SHOWGROUND PRECINCT EAST

3 ANDALUSIAN WAY, CASTLE HILL

DESIGN EXCELLENCE REPORT

STATE SIGNIFICANT DEVELOPMENT APPLICATION

Vehicular movement

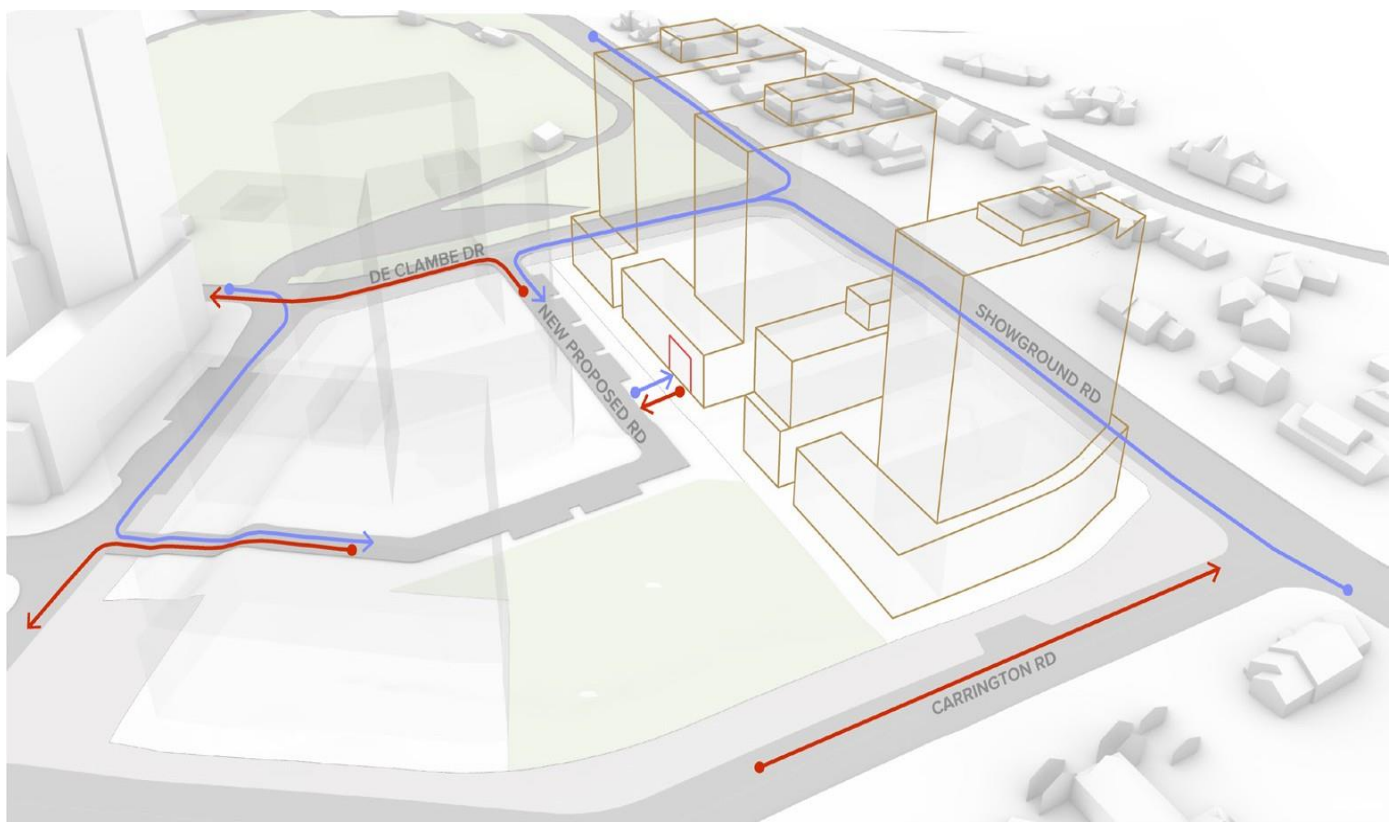
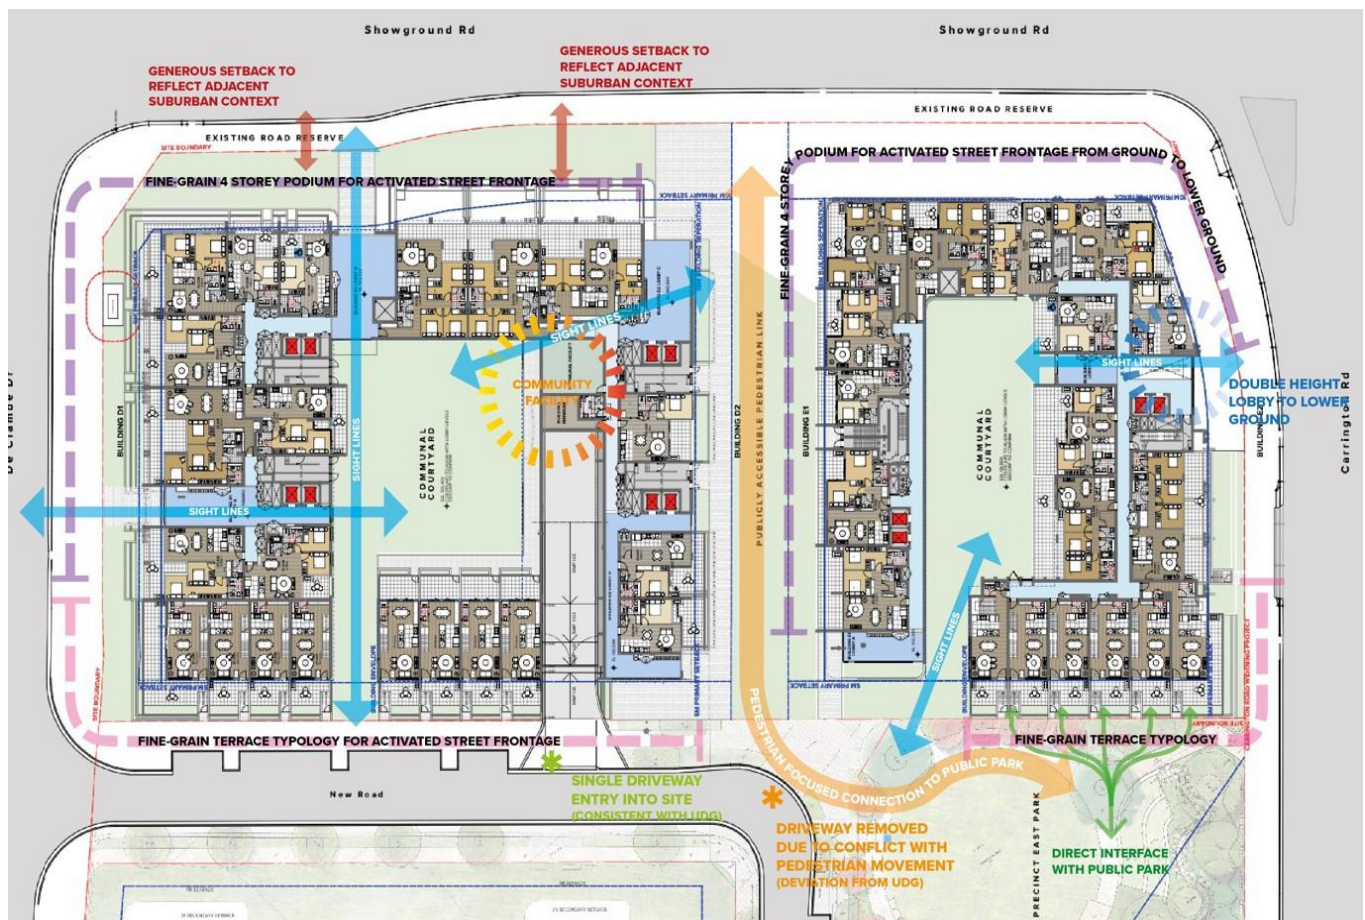
“5. While pedestrian crossings and cycle paths are outside of the scope of this proposal, ensure site access, landscape design and building entries respond to the broader network, and infrastructure is provided, including bicycle parking.”

The proposal seeks to deliver a pedestrian centric public domain where the impact of cars and traffic movement is carefully managed. A key design move has been the consolidation of the car park entries and loading docks for Buildings D & E into a single entry/exit point located on the sub-divided road. This has removed traffic movement conflicts at the western end of the publicly accessible pedestrian link. The loading dock is located within the basement and allows for trucks to enter and exit the site safely in a forward's direction.

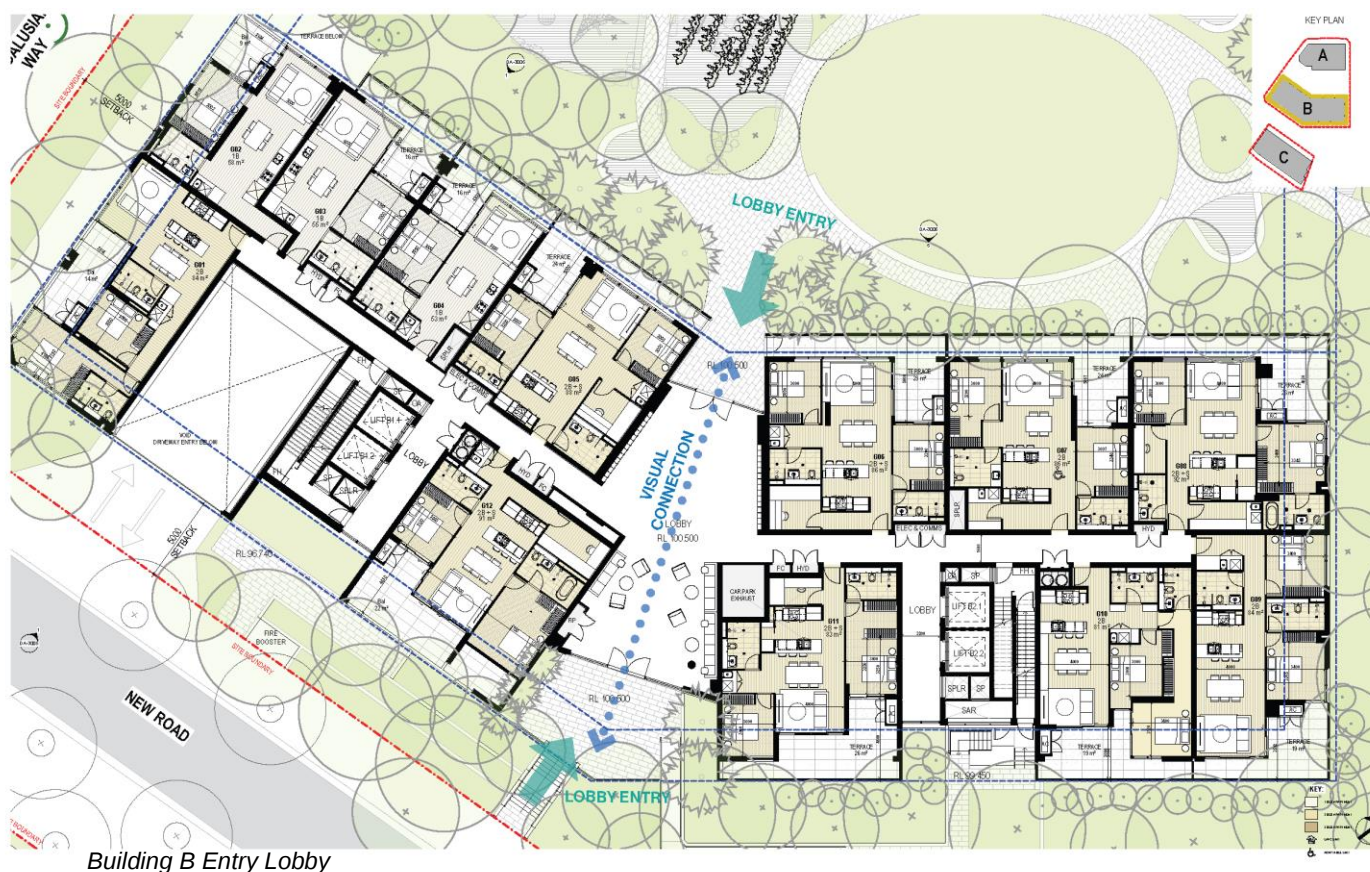
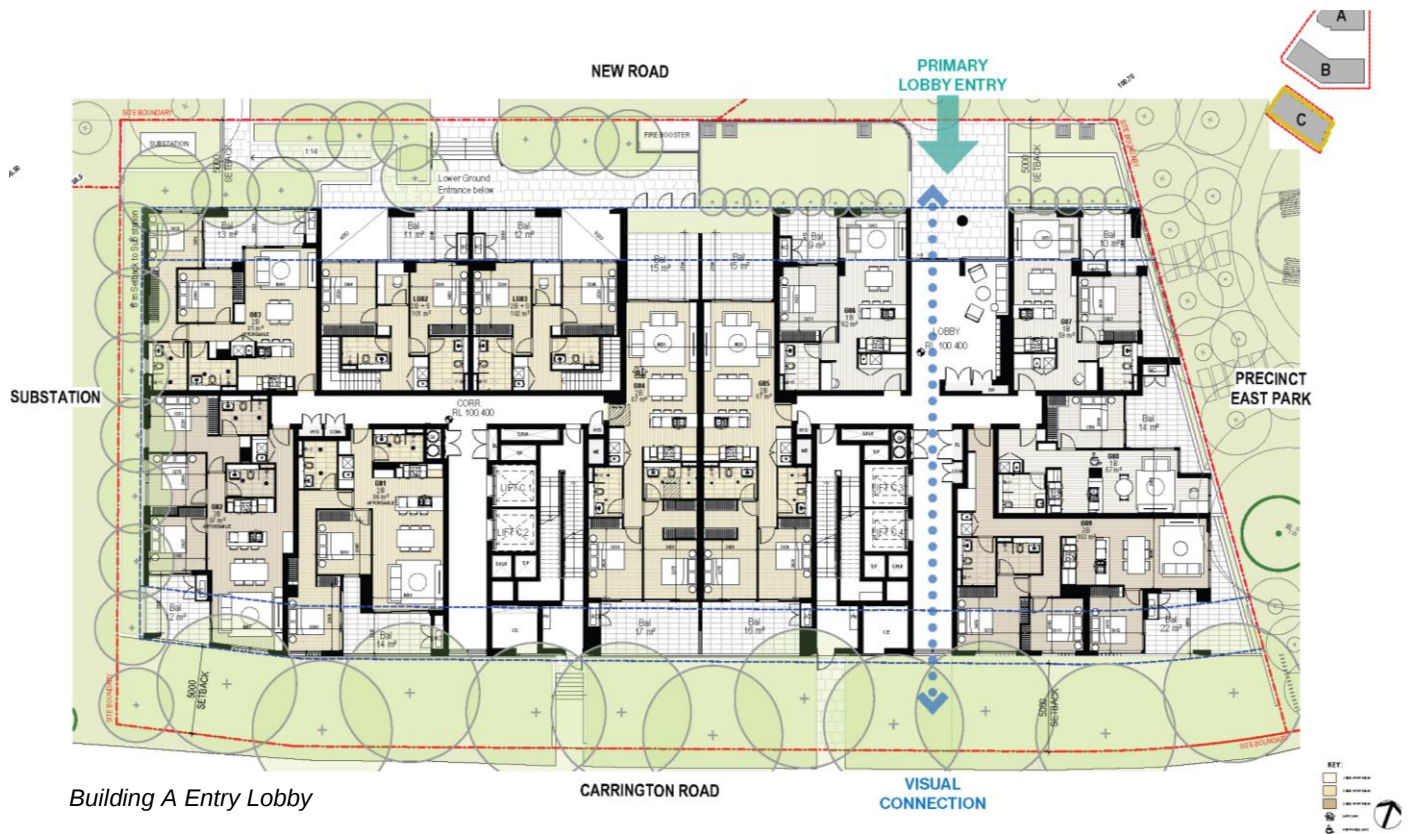
“Sightlines from the public domain through to the communal courtyards are supported. Reconfigure entrance lobbies to ensure this is achieved for all blocks across the precinct.”

A key design move was to provide a more generous entry centrally located in Building B forming both a pedestrian link for residents and direct sightlines from New Road to the central courtyard beyond. Similar updates to Building A & C provide direct views through both lobbies visually connecting the public domain.

Basement Cross Section

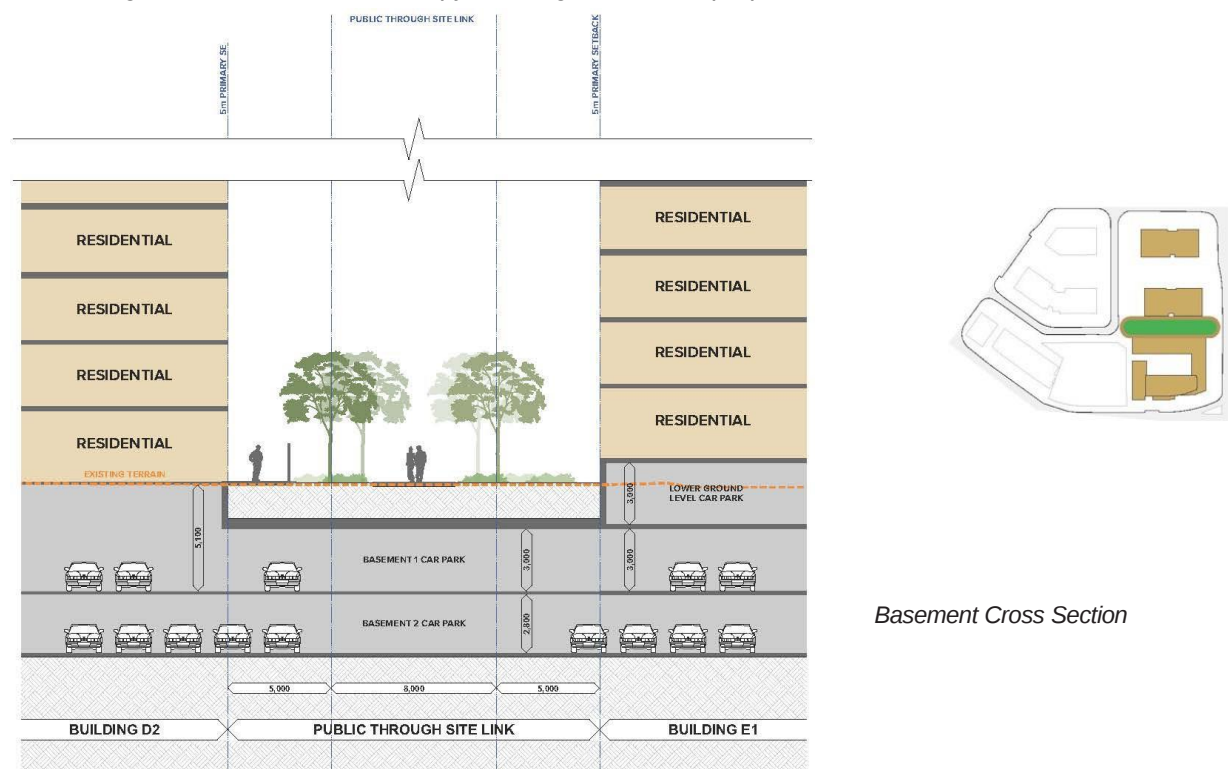
“Reconfigure the basement design to increase soil provision to public streets.”

The car park generally sits directly under the footprint of the buildings overhead. The extent of car park does not fill the site and has generous setbacks from all of the site boundaries. The car park has been designed to allow for significant deep soil areas, which is in excess of the ADG requirements.

A key design move has been the consolidation of the car park entries and loading docks for Buildings D & E into a single entry/exit point located on the sub-divided road. This has removed the need for driveways and hard landscaping at the western end of the publicly accessible pedestrian through site link. The consolidated loading dock is located within the basement and maximises the efficiency of the carpark extend.

Within the publicly accessible pedestrian link, the proposal incorporates a 2m set down of the basement slab. This allows for significant soil depth sufficient for large tree types and quality soft landscaping. The 2m set down for soil allows for a flush condition within the public domain, free of mounding and low retaining walls, for a more open and permeable streetscape.

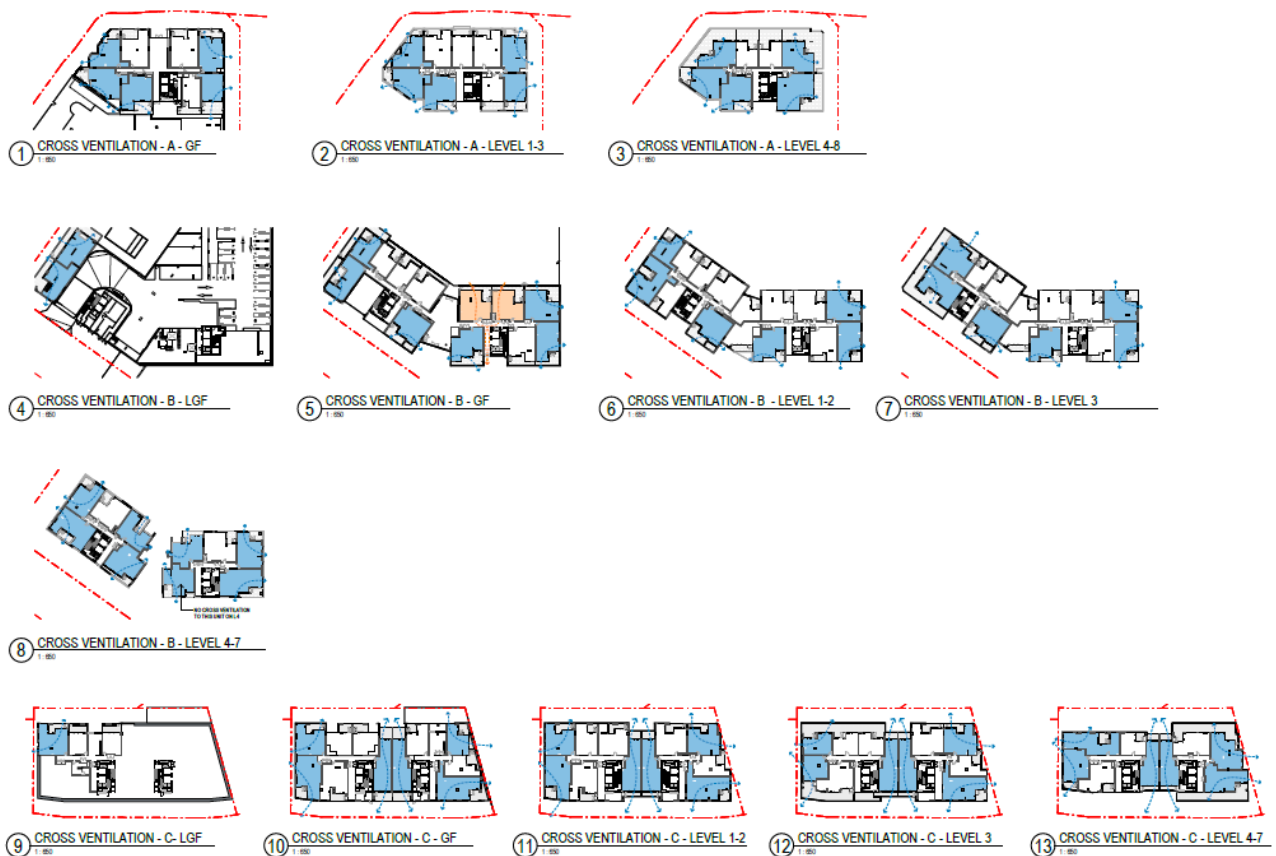
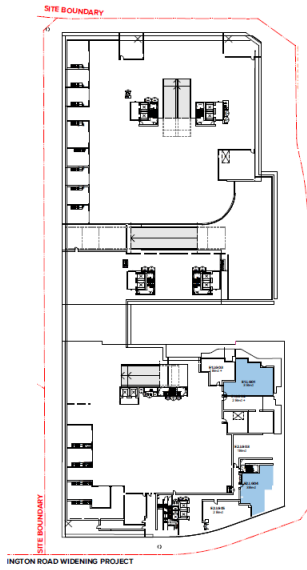
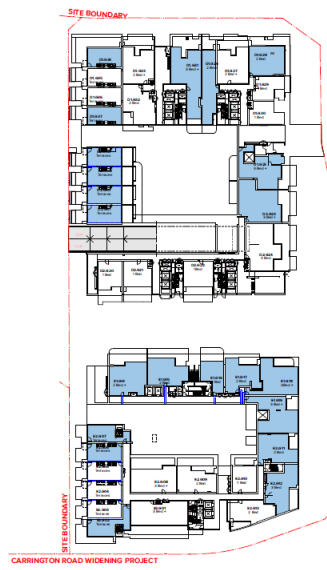
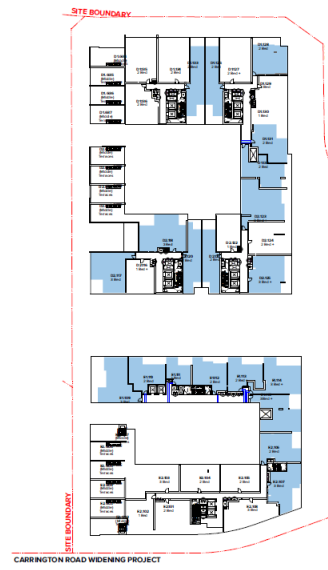
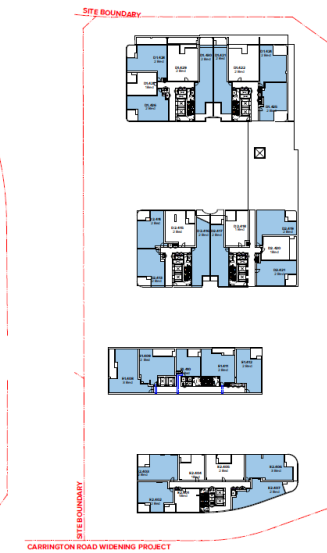
Demonstrate that apartments noted as having cross ventilation are genuinely dual aspect. Layouts may need to be reconfigured to achieve ADG compliance.

62% (154) Apartments achieve natural cross ventilation.

To achieve the required natural cross ventilation in Lots 3 & 4, the concept plan massing of Building B tower is sub divided into Tower B1 & B2. This approach reduces the bulk and scale of Building B's massing while enhancing the cross ventilation in corner units.

As noted at the first SDRP review, the proposed design replaces through 3B units located on L1-3 in Building B. The reconfigured design enables stacked unit types in the tower & podium, with smaller one bed units located on L1-3 providing improved structural rationalisation while maintaining ventilation requirements.

In order to meet ADG cross ventilation requirements for Building D & E, Turner has included 2 cores within each of the towers. This results in typically only 4 or 5 apartments off a single core on each level and minimises any south facing single aspect apartments. This key design move has resulted in apartments with a high level of amenity and outlook.

Due to the two cores within each tower, there are four corner apartments at the edges of the building, plus two dual aspects through apartments in the centre of the floorplate. Within the podium levels, the lower buildings facing Showgrounds Road are often narrow single loaded buildings with a predominance of dual aspect apartments that face both onto Showgrounds Road and into the communal courtyard to the rear.

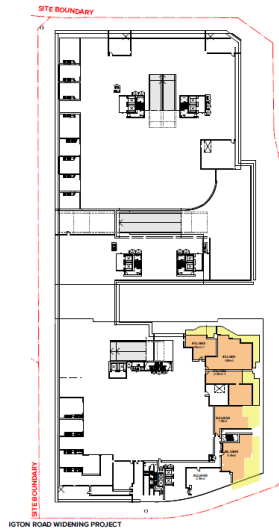
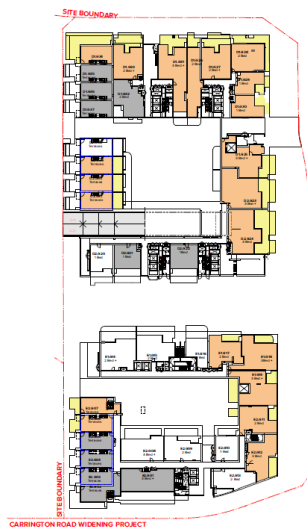
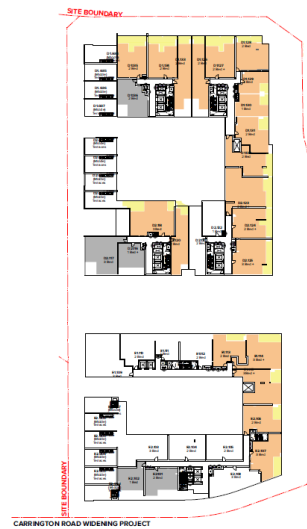
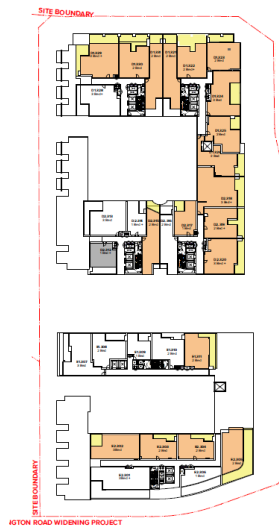
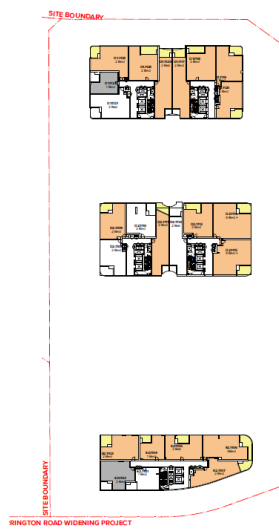
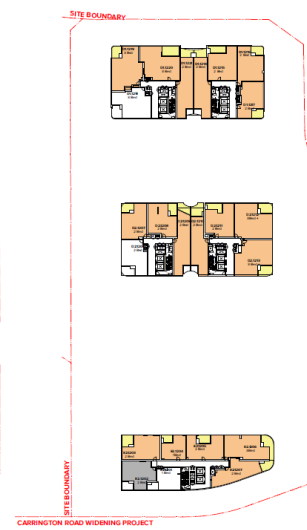
Ensure that single aspect apartments have sufficient access to natural light, specifically the south-west facing ground floor terrace houses to Lot 5.

The townhouses along the western side of Buildings D & E are three storeys in height, with significant glazing to their street edge interface. The highly indented façade allows for corner style windows to each townhouse that capture the views to the Showgrounds to the north of Building D or to the new Eastern Park which is located to the west of Building E. This generous bay window allows afternoon light to the townhouses from 1pm onwards, sufficient to meet ADG requirements. This has been balanced with solar and weather protection considerations via canopies and awnings to allow for private open space that is usable for residents. Refer to the Turner sun eye diagrams what show the facades of the majority of the townhouses achieving adequate solar access.

It should be noted that the majority of the townhouses are either corner locations or dual aspect with glazing on either two or three side of townhouse.

Refer to the Turner ADG amenity plan diagrams and to the sun eye diagrams which adequately show that the proposal meets the ADG % requirements for solar access.

Further to the above points, Turner note the two cores located within each of the towers, this allows for a predominance of corner and dual aspect through apartments and an avoidance of single aspect apartments, and minimal south facing units.
